Nine Mile Point
Nuclear Station

November 15, 2002
NMP1L 1697

SUBJECT: Nine Mile Point Unit 1
 Docket No. 50-220
 License Amendment Request Pursuant to 10 CFR 50.90: Revision
 of Reactor Pressure Vessel Pressure-Temperature Limits and
 Request for Exemption from Requirements of 10 CFR 50.60
 TAC Nos. MB6687 and MB6703

FIGURE 3.2.2.a

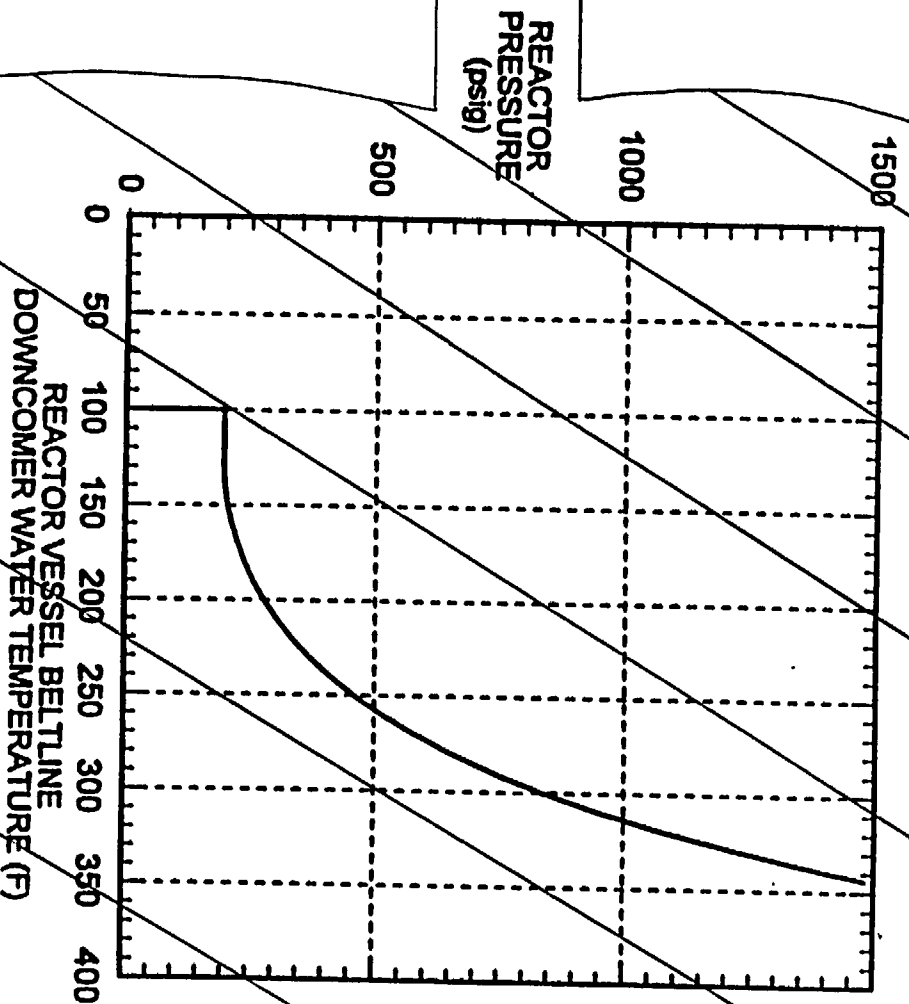
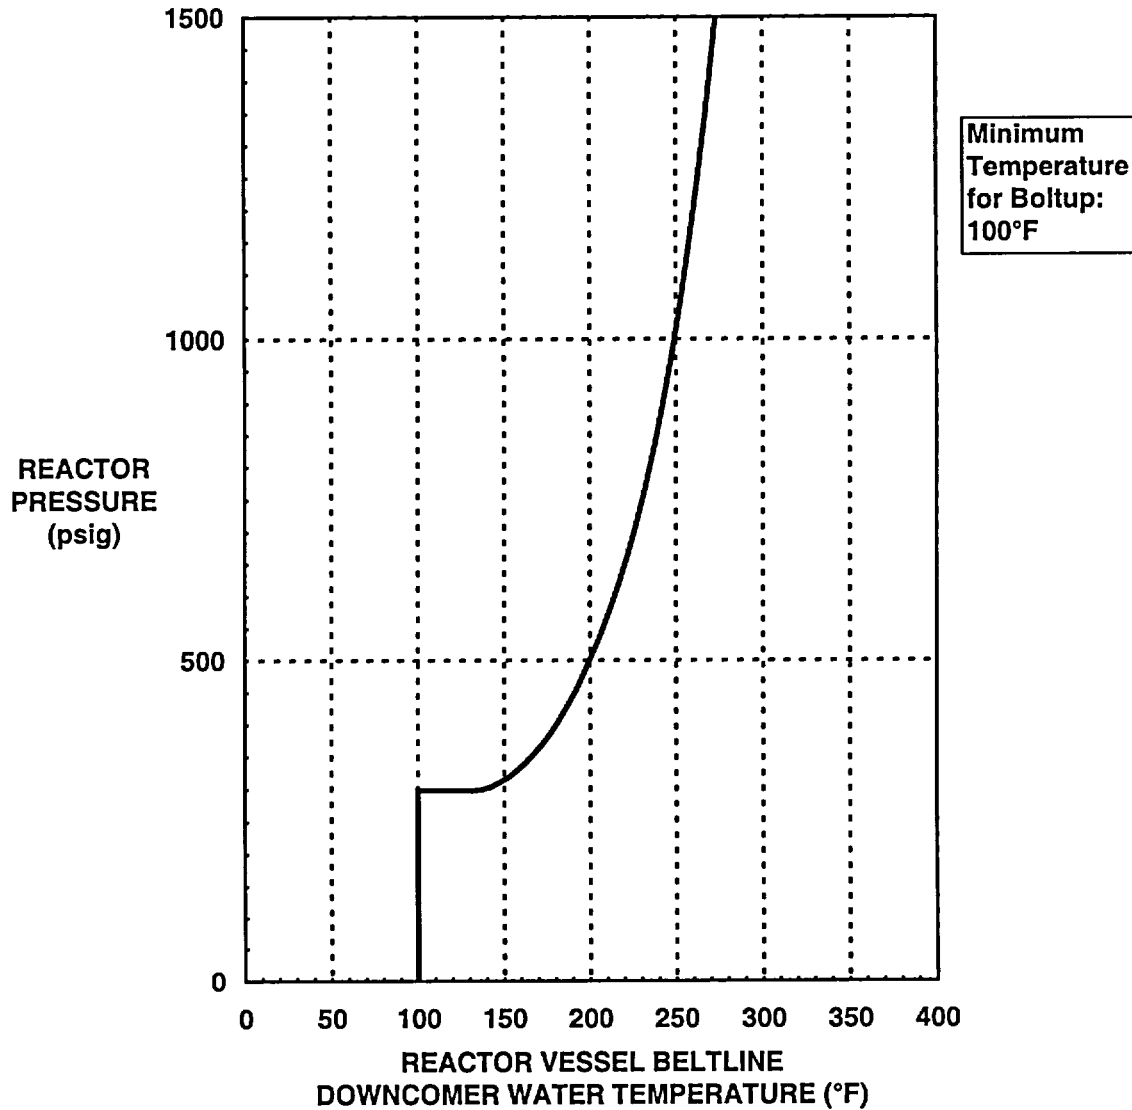
TS Figures 3.2.2.a and b and Tables 3.2.2.a and b are being replaced with new figures and tables to provide RCS P-T limits that continue to be valid for up to 28 EFPY and that are applicable to reactor vessel heatup and cooldown with the reactor core not critical.

INSERT
FIGURE 3.2.2.4

INSERT FIGURE 3.2.2.a

FIGURE 3.2.2.c

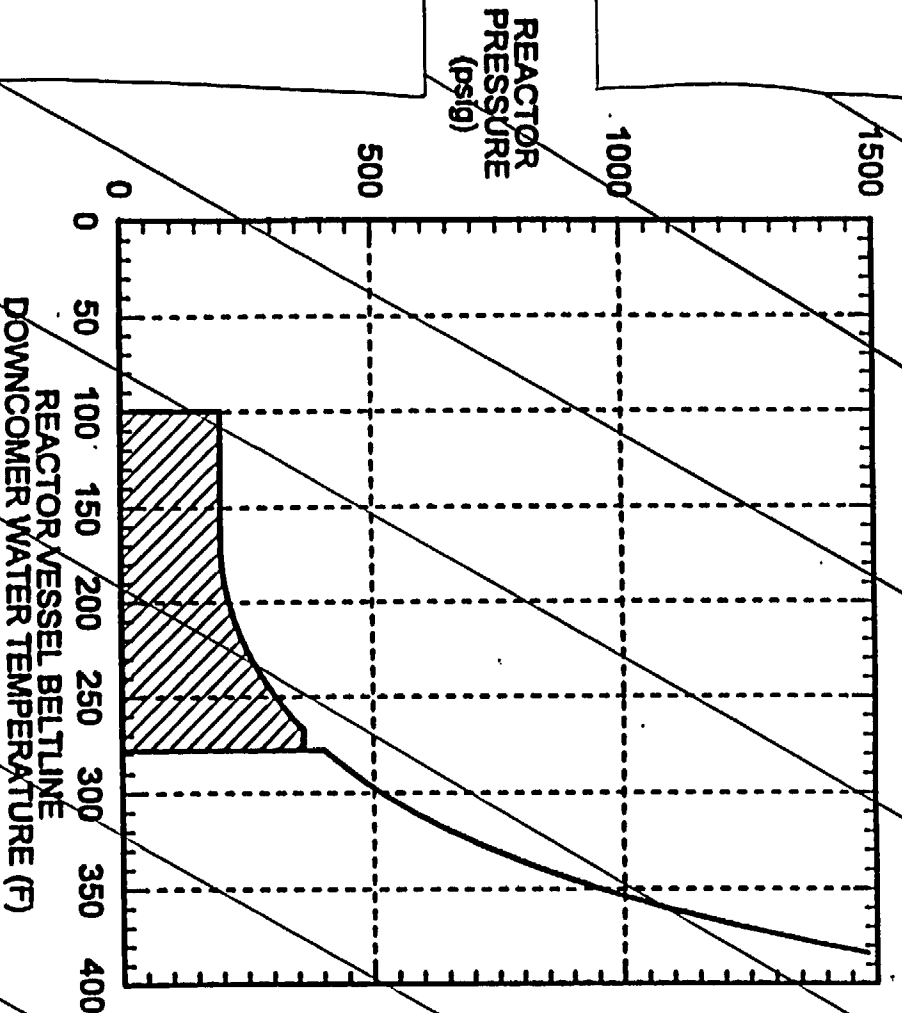
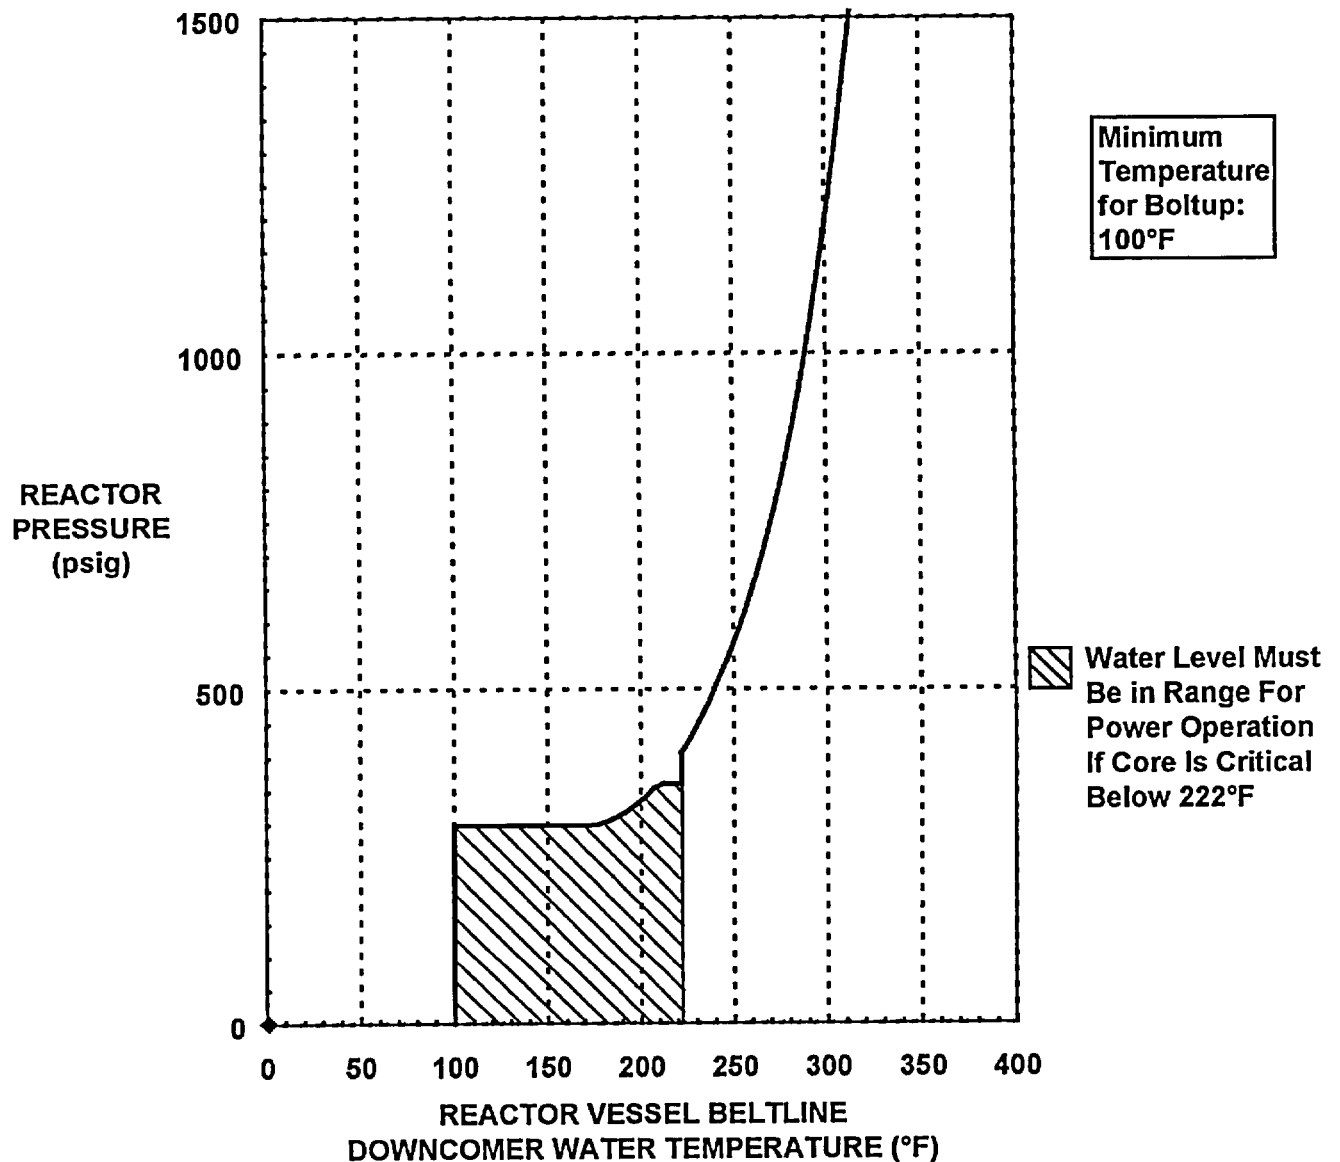
TS Figures 3.2.2.c and d and Tables 3.2.2.c and d are being replaced with new figures and tables to provide RCS P-T limits that continue to be valid for up to 28 EFPY and that are applicable to reactor vessel heatup and cooldown with the reactor core critical.

INSERT FIGURE 3.2.2.c

FIGURE 3.2.2.e

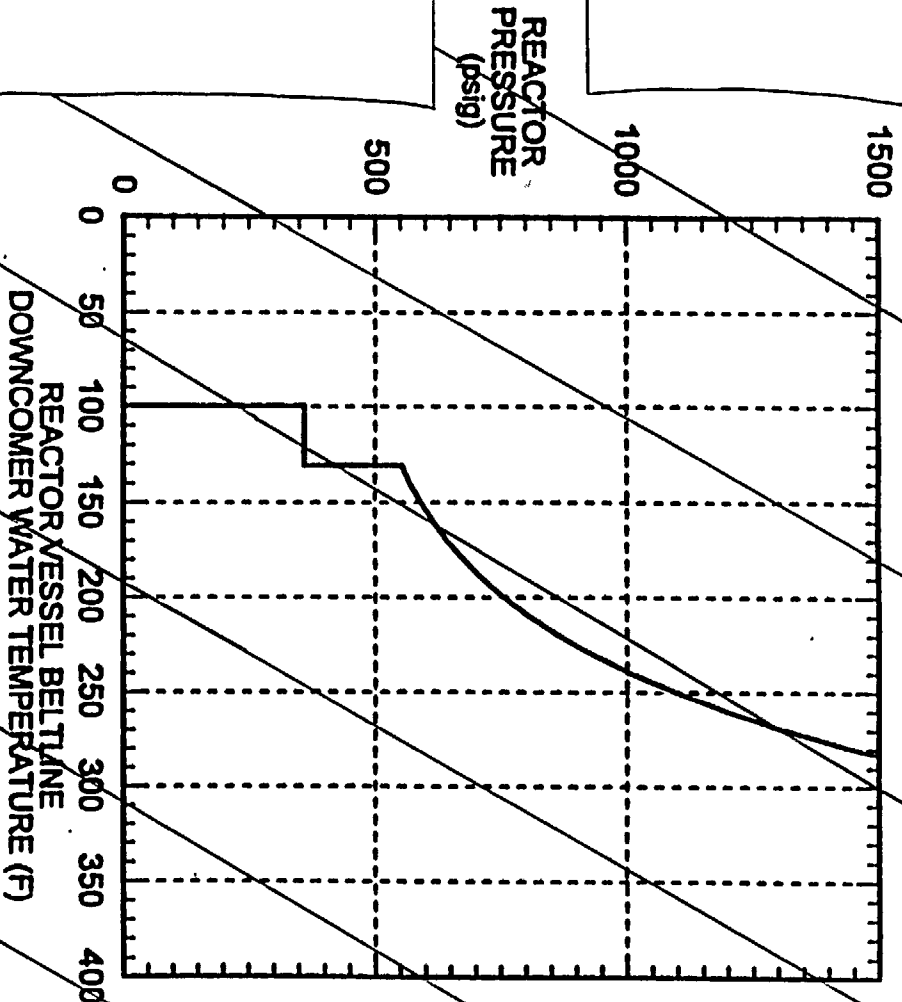
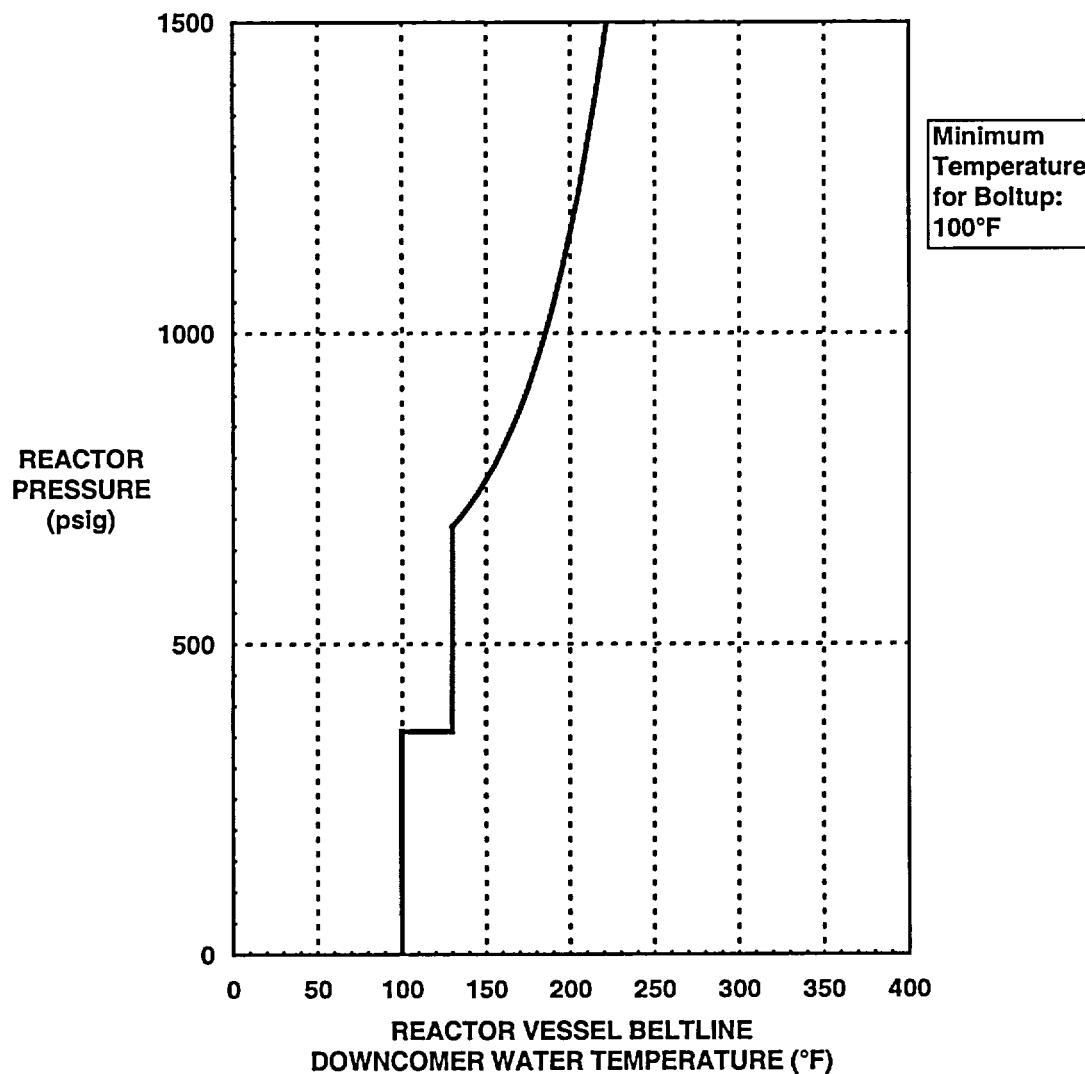
TS Figures 3.2.2.e, f, and g and Tables 3.2.2.e, f, and g are being replaced with a new single Figure 3.2.2.e and a new single Table 3.2.2.e to provide RCS P-T limits that are valid for up to 28 EFPY and that are applicable to hydrostatic and leak tests. Figures 3.2.2.f and g and Tables 3.2.2.f and g are being deleted since they have been superseded by the new single (28 EFPY) figure and new single (28 EFPY) table.

INSERT FIGURE 3.2.2.e

FIGURE 3.2.2.g

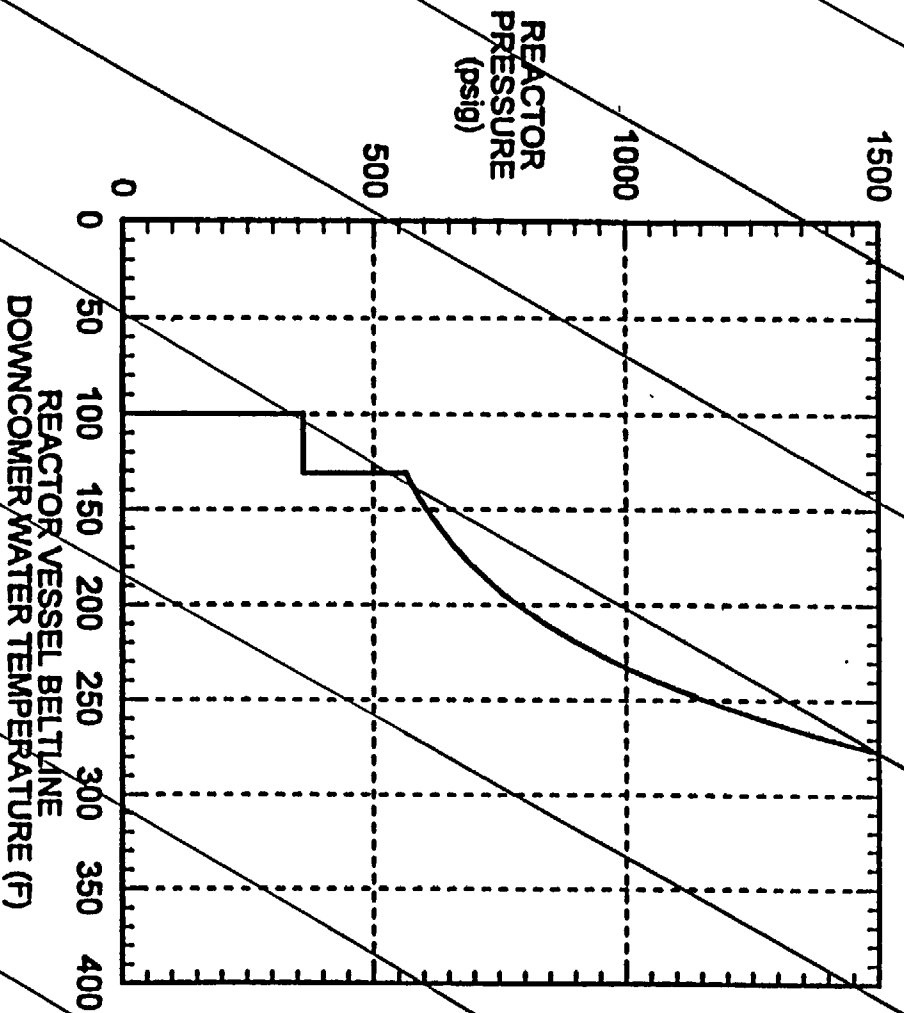
THIS PAGE DELETED
